SUBJECT: Forwards response to draft SER open issues & outstanding open branch meeting issues.

Subject: NUCLEAR PROJECT NO. 2  
SUBMITTAL OF SER OPEN ISSUES

Enclosed are sixty (60) copies of our submittal responding to draft SER open issues and outstanding open branch meeting issues. For ease of review, the pertinent draft SER pages or branch question precedes each issue. A tabulation identifying each item and indicating its resolution status or schedule for close out is also provided.

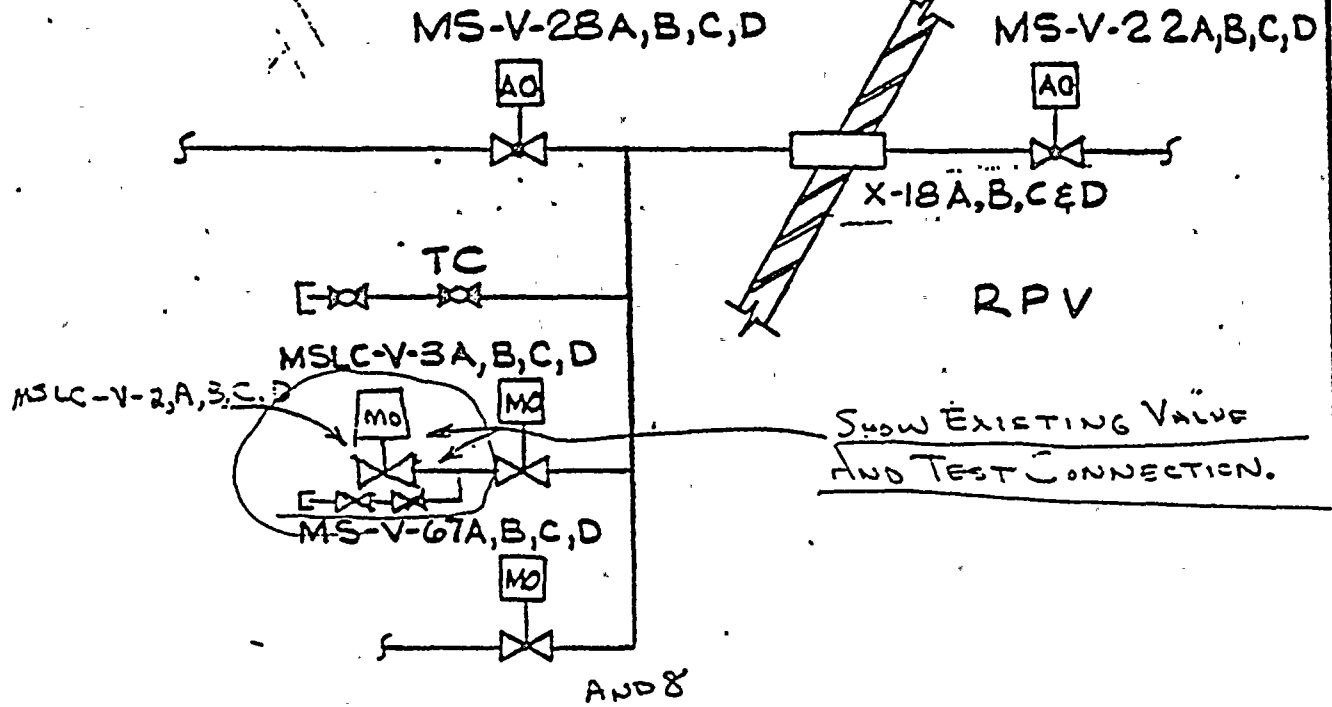
NRC: Figure 6.2-31j - are all four LCS valves on mainstream isolation valves tested at the same time?

Supply System: The Supply System will revise Figure 6.2-31j to show a capability to test the valves individually.

Resolution: Revised Figure 6.2-31j attached.

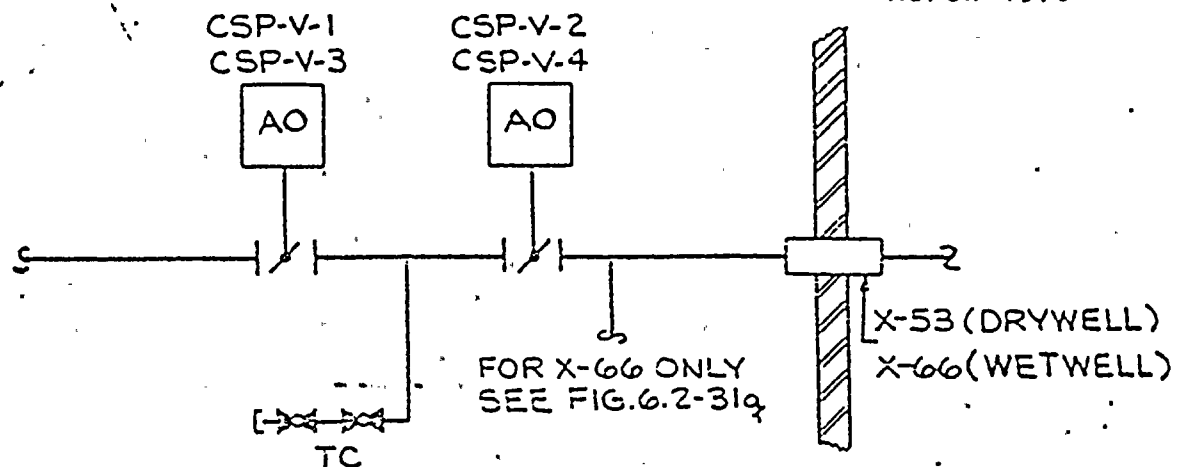
NRC: Figure 6.2-31b, feedwater line RWCU-V-40  
How is this valve to be tested?

Supply System: The Supply System will revise Figure  
6.2-31b to indicate test connections  
available for RWCU-V-40.

Resolution: Revised Figure 6.2-31b attached.

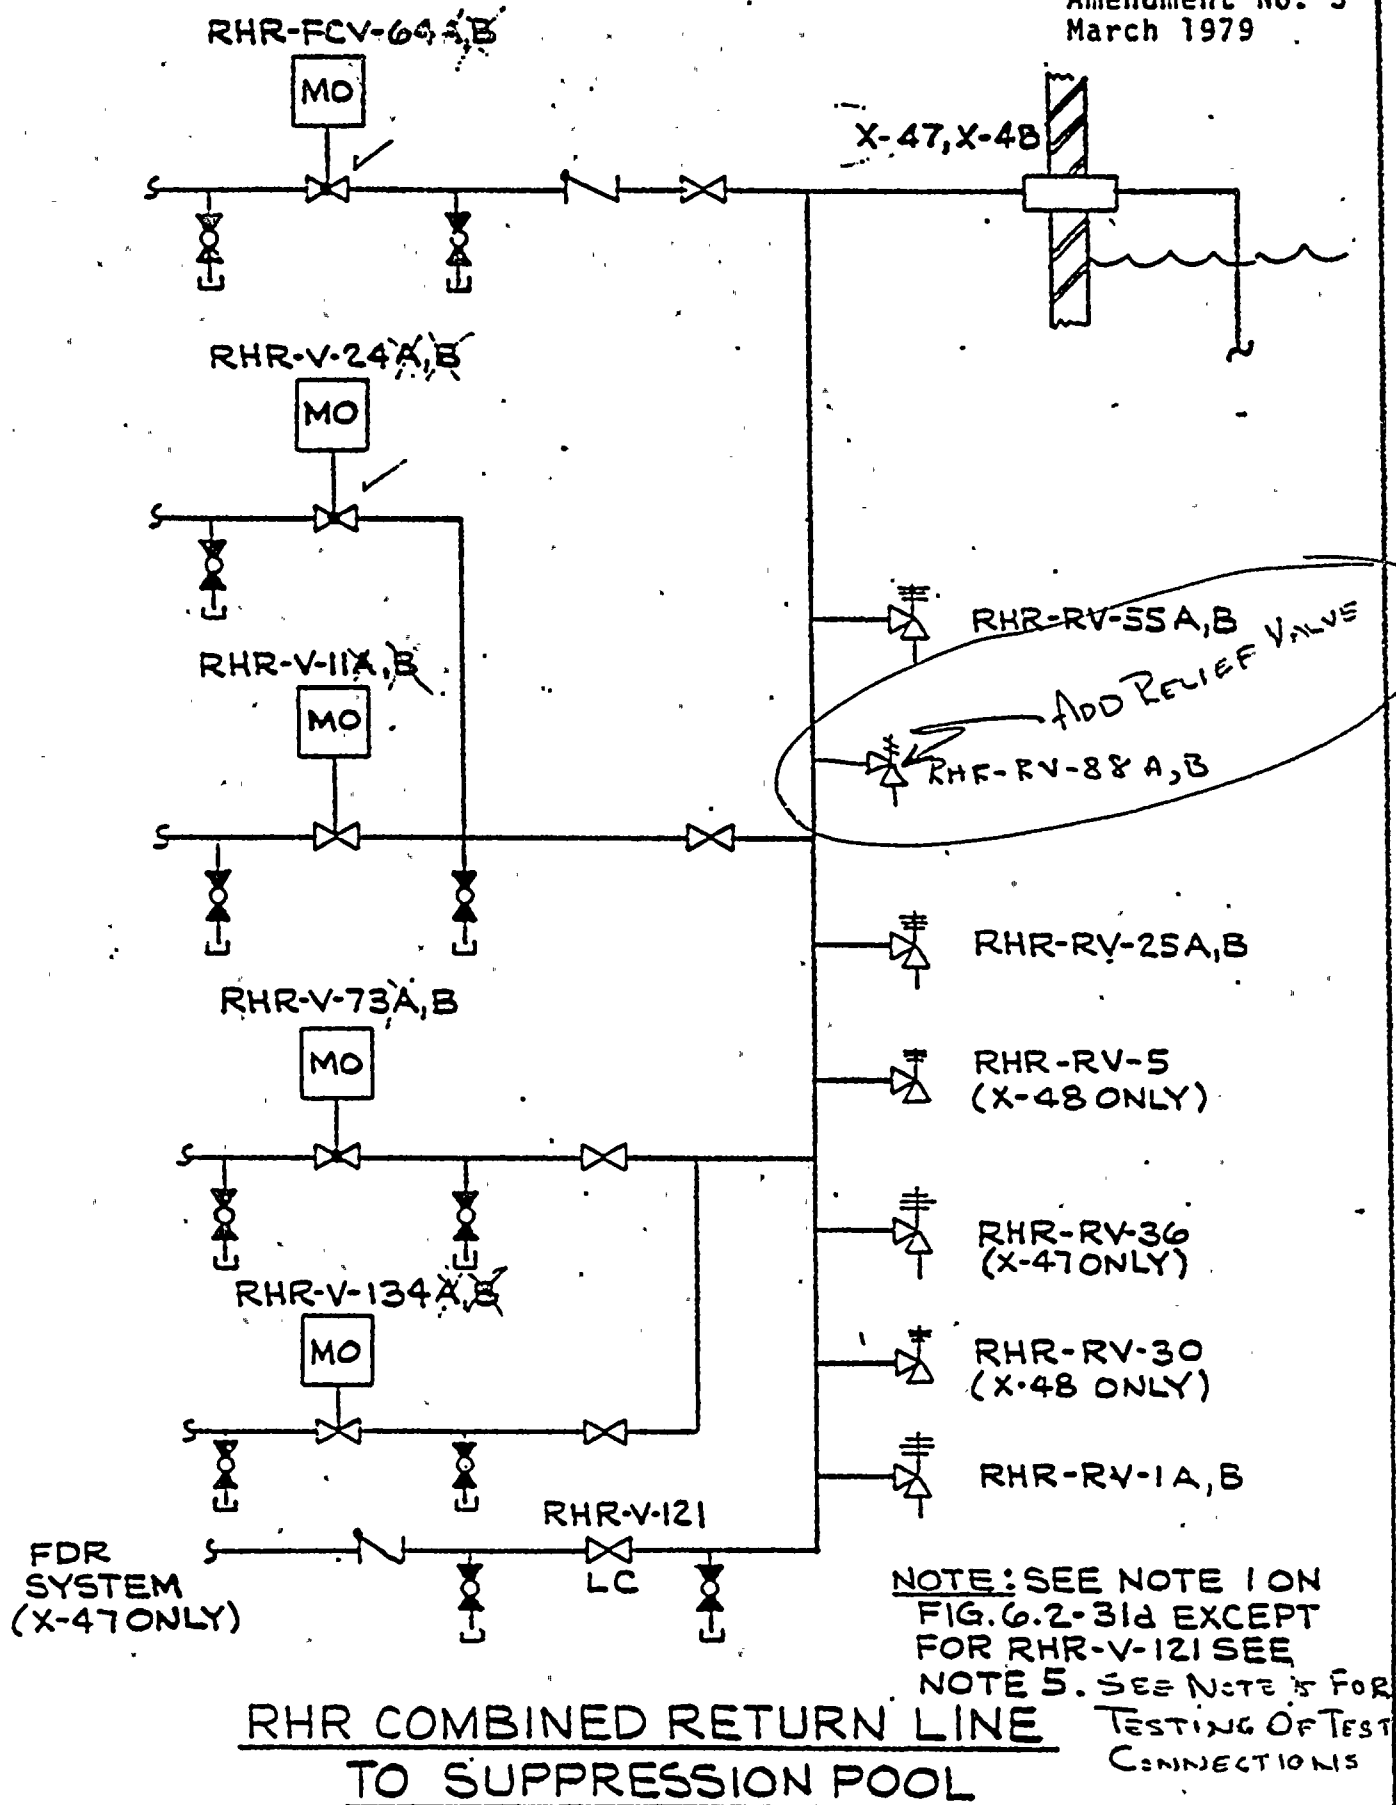
NRC: Page 6.2-125, RHR-88a, pump suction relief valve, is not shown in Figure 6.2-31p.

Supply System: Figure 6.2-31p will be revised accordingly

See revised FSAR Figure 6.2-31p (attached).

## Issues 19 and 24

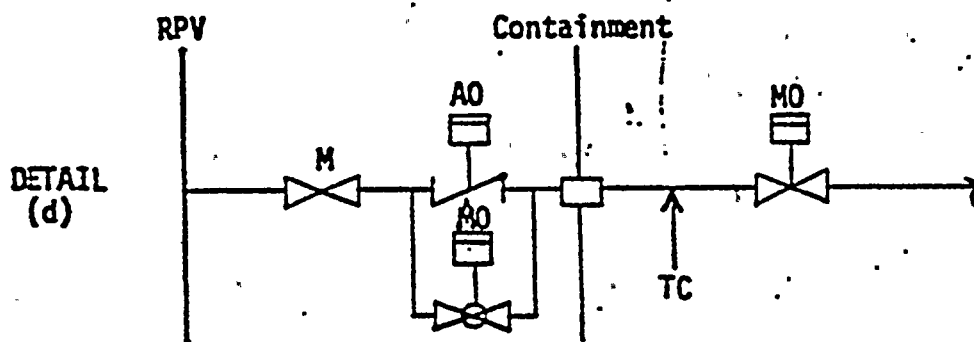
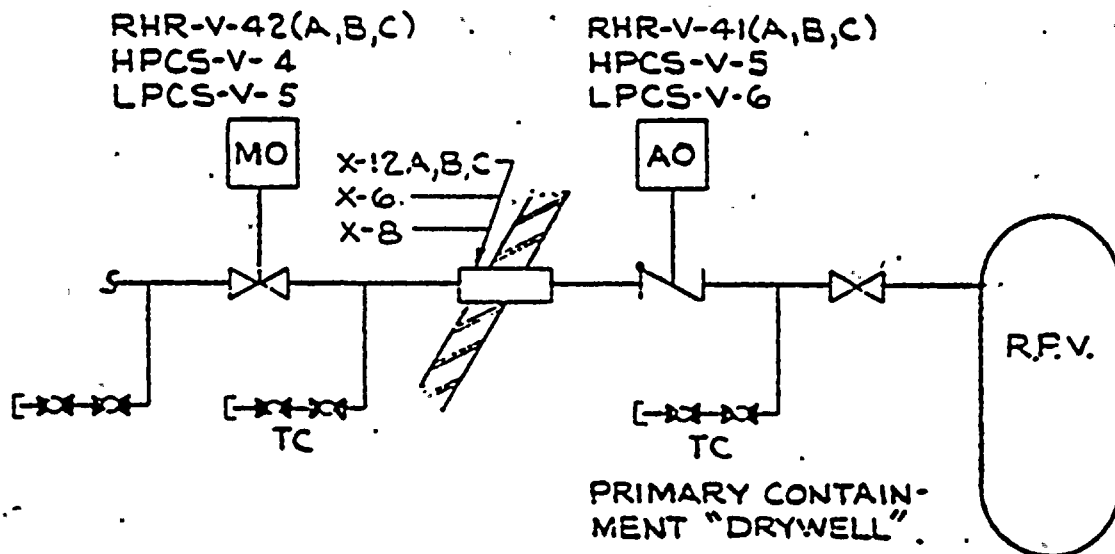
The WNP-2 LaSalle isolation valve designs for the LPCI injection valve are similar. The only difference is that LaSalle has a 3/4 inch air-operated globe valve in parallel with the check valve inside containment, which have isolation signals to close. WNP-2 has no such bypass line. Neither WNP-2 or LaSalle has isolation signals to close the LPCI injection valves. WNP-2 uses valve packing leakage indication, and reactor bldg. sump level indication, as well as reactor water level and suppression pool water level instrumentation to alert the operator of excessive leakage.

The LaSalle isolation design for the LPCI containment penetration is similar to the WNP-2 design in that containment isolation is provided by a motor operated gate valve outside containment and a testable check valve inside containment, (see Figure 1). The only difference in the design is that LaSalle has a 3/4-inch globe valve in parallel with the testable check valve inside containment.

The 3/4" air operated globe valve receives the reactor vessel low-low water level and high drywell isolation signals, has remote manual operation from the control room and fails closed on loss of power. The only signal to the LPCI injection line isolation valves, however, is a remote manual signal to the gate valve outside containment, which is identical to the isolation valve control logic at WNP-2.

The Supply System will relocate check valves and containment isolation valves inside containment. See revised FSAR pages 6.2-130 and 6.2-131 and Figures 6.2-31c and 6.2-31r (attached).
